Lead Local Flood Authority

RE: DC/26/0592 Land at Lower Broadbridge Farm Billingshurst Road Broadbridge Heath Horsham West Sussex RH12 3LR

Thank you for your reconsultation on the above site, received on 18th August 2026. We have reviewed the application as submitted and wish to make the following comments, highlighted in [blue](#).

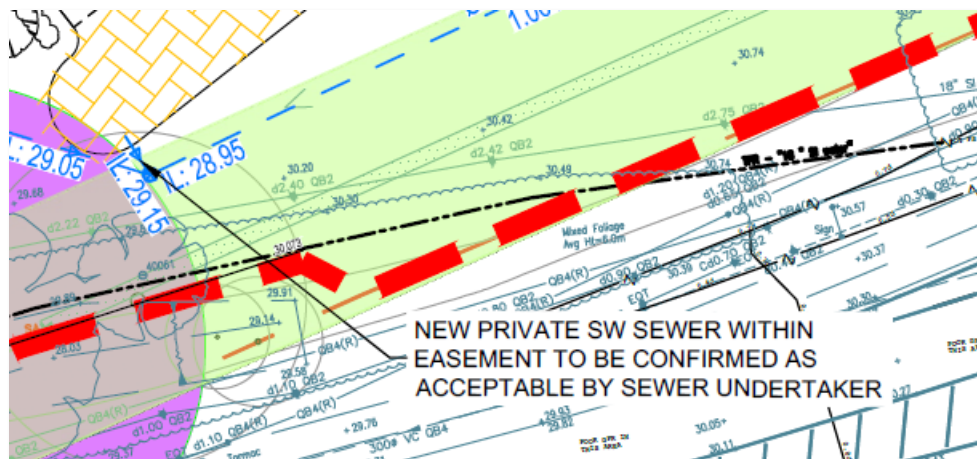
1. Evidence of the Applicant's conformity with Standard 1, Priority 1 of the National Standards for SuDS (collection for non-potable use), as West Sussex is classified as a water stressed area.

[This has not been addressed, the applicant should include rainwater harvesting for non-potable use within their scheme in order to comply with the NPPF.](#)

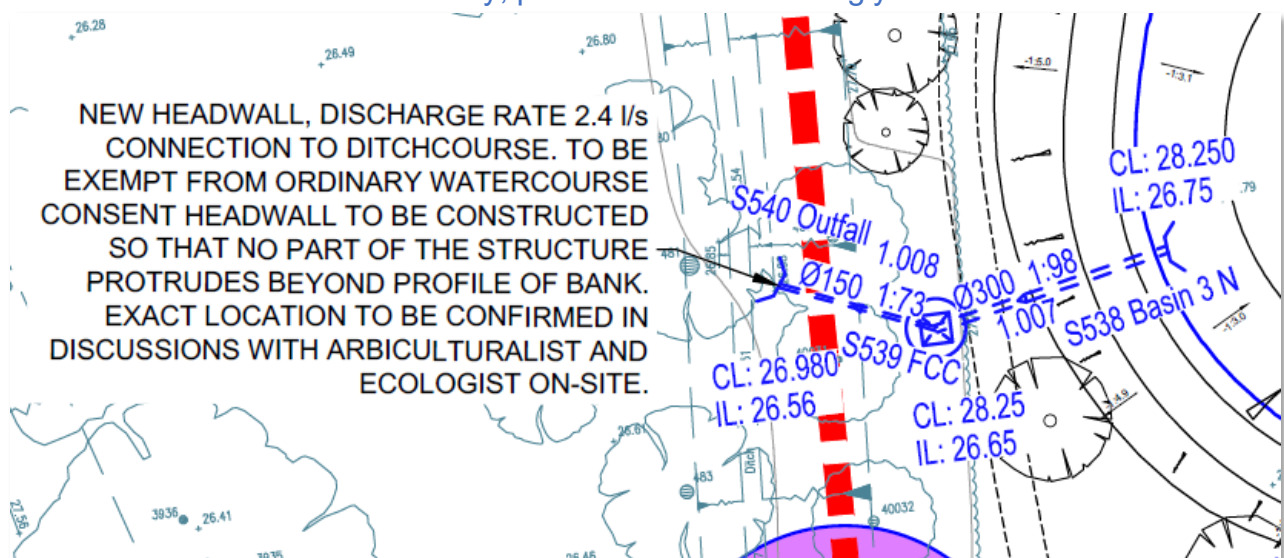
c. Confirmed headwall locations with invert levels and labelling confirming right to utilise the bank if outside the redline boundary

The below headwall still appears to be unconfirmed in terms of location and is currently drawn as outside the site boundary, please amend accordingly:

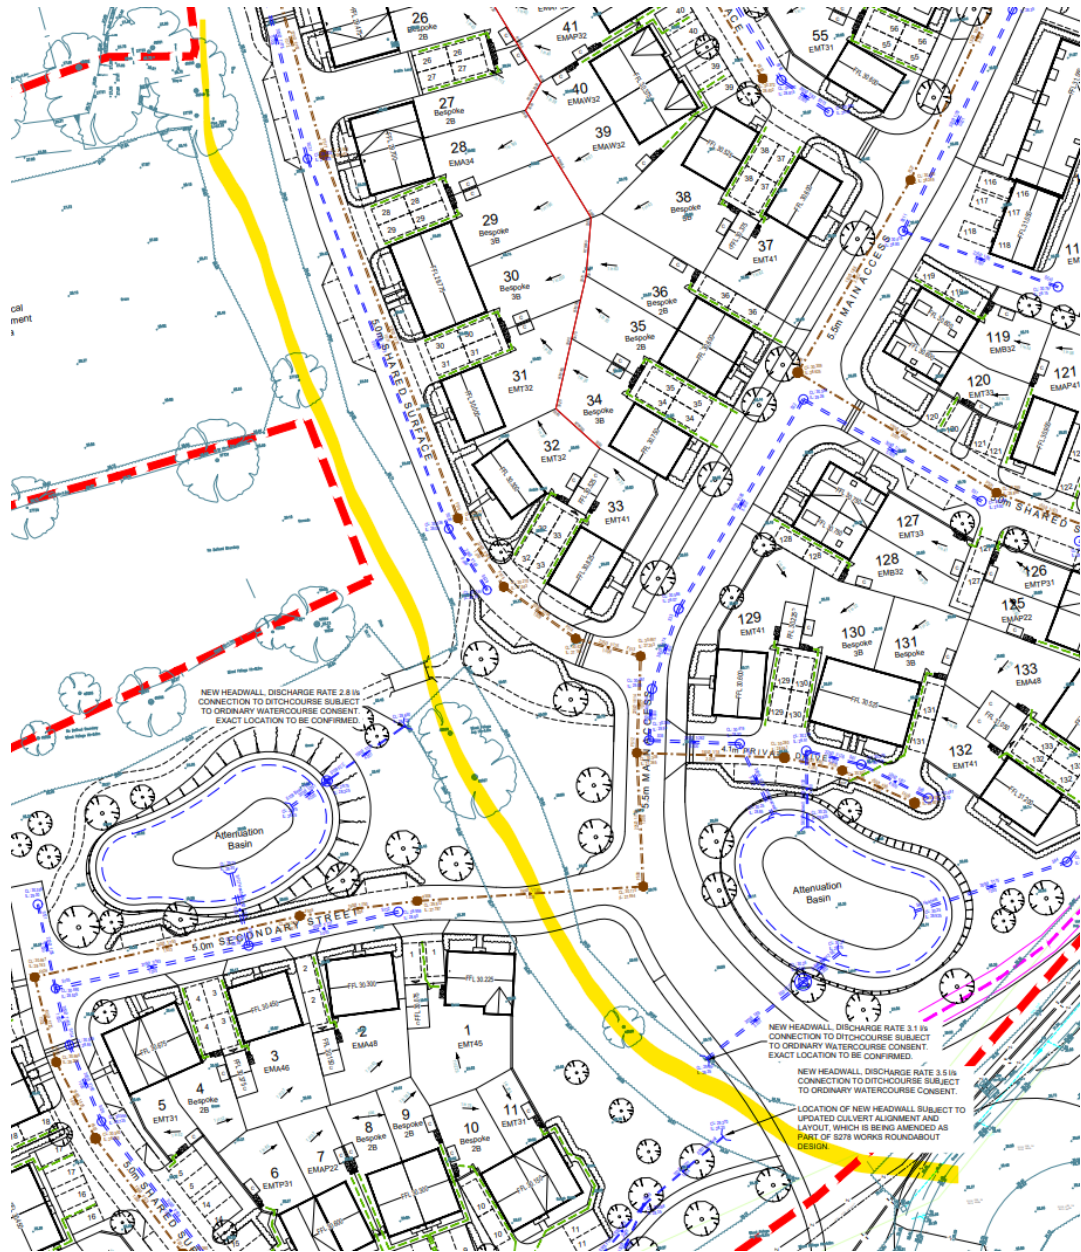
- This has been completed for outfall headwalls, however please also update for any culverts and watercourse realignment, for example in the area highlighted below (which appears to require a culvert for the access road and realignment via S278 works):

(from drainage layout with watercourse marked in yellow)

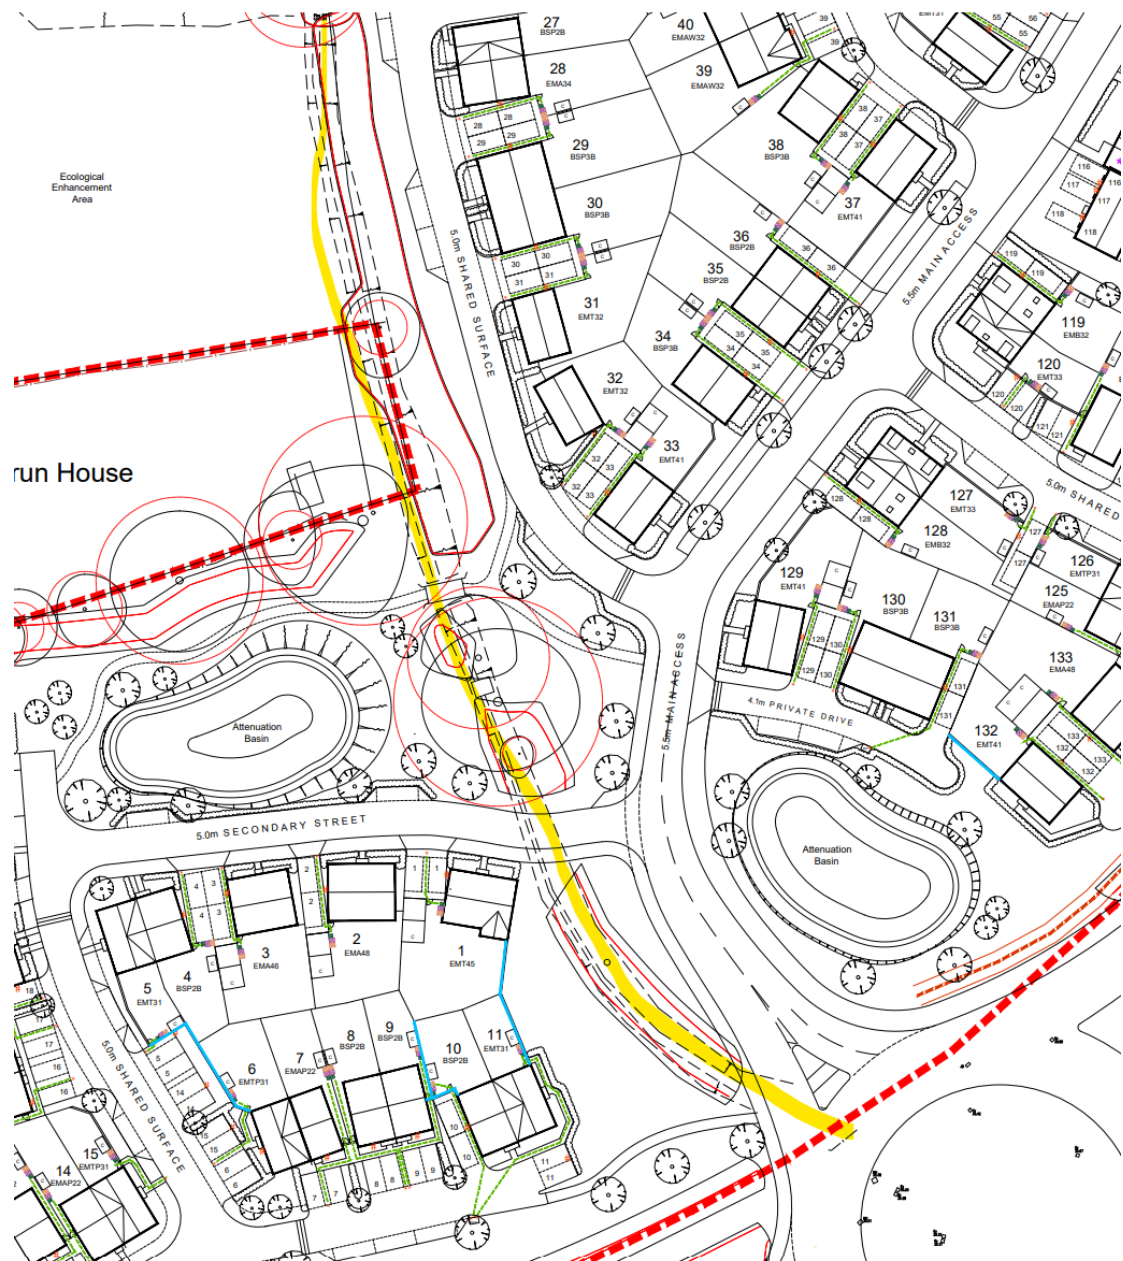
f. We also note there will be amendments to the existing watercourse, please ensure the plan includes the updated course as proposed:

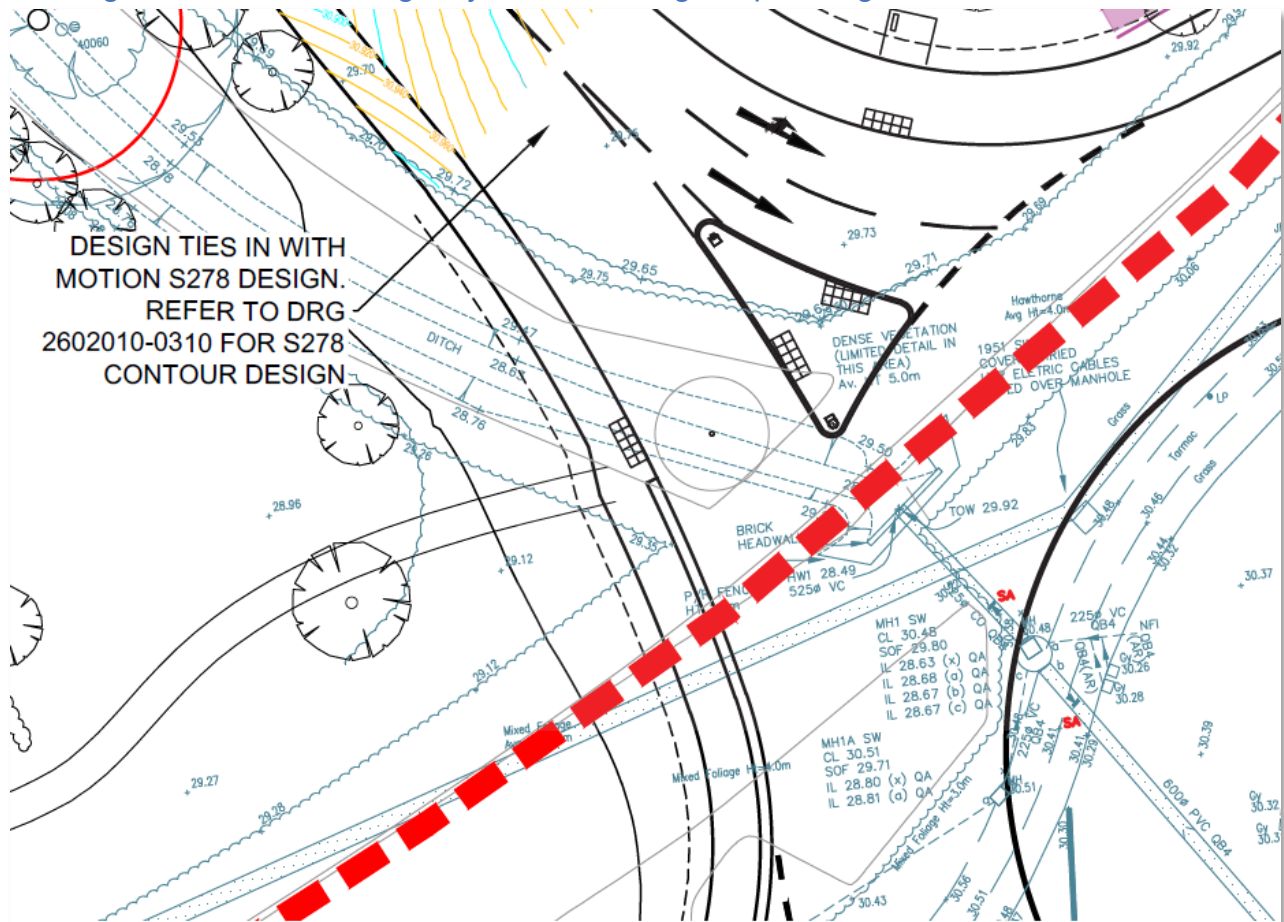
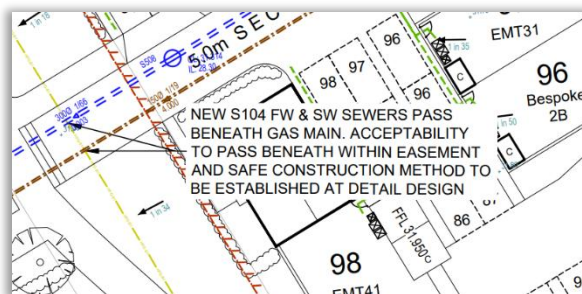
There are still conflicts with the revised road layout and the existing watercourse layout, see below example. We note the Applicant states at 3.5.3 *“There is an existing SW culvert which discharges into the existing watercourse on site, at the location of the new roundabout arm into the site. This is proposed to be extended into the site as part of the*

separate highway works, to accommodate the new roundabout design. It is not envisaged that these works will affect the proposed development". However we would still require a plan showing the finalised drainage layout at this stage of planning.
